CLEVE HILL SOLAR PARK – DEADLINE 4 SUBMISSION

Following my submission at the Open Floor Hearing on 22 July, I wish to challenge a number of statements made in the Outline Construction Traffic Management Plan, Document reference: 6.4.14.1, Revision B, submitted by the Applicant for Deadline 3:

Measurement 13 – 5.5m

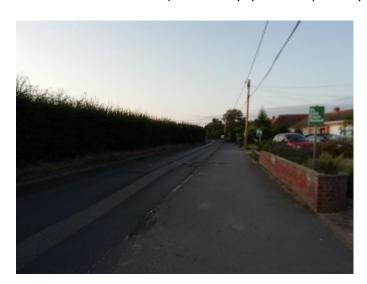
- As can be seen, the minimum width measured was 4.2m and the maximum 6.1m, both of which are outside the parameters provided by the Applicant.
- Additionally, the Applicant stated in their Written Summaries of Oral Submissions, Document Reference 11.1.1, Revision A, that "a bus is expected to be able to pass an HGV, as can occur in the existing baseline scenario when HGVs utilise the same route." Anyone who uses these roads knows that this statement is completely untrue and misrepresents the reality of the situation which will occur should this proposed development go ahead. Based on my measurements of the local bus (2.8m including wing mirrors) and the Hilderbrands Removal lorries (2.6m including wing mirrors) this makes a total of 5.4m WITH NO GAP BETWEEN.

- Out of the 25 measurements I took, these vehicles would only be able to pass in a maximum of 3 places (12%) with a gap ranging between 0.1m and 0.6m.

Measurement 14-4.8m (excludes layby which is privately owned)

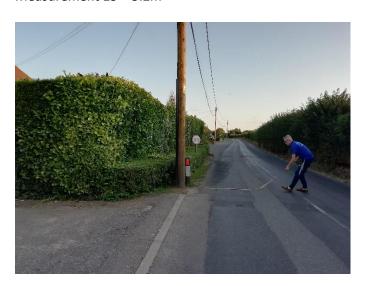
- This is completely untrue. Currently, the only places where it is possible to wait for large vehicles to pass are on private property, e.g. wide driveways and the privately owned layby along Seasalter Road. Additionally, the road is narrow with many bends which cannot be seen around due to high verges.
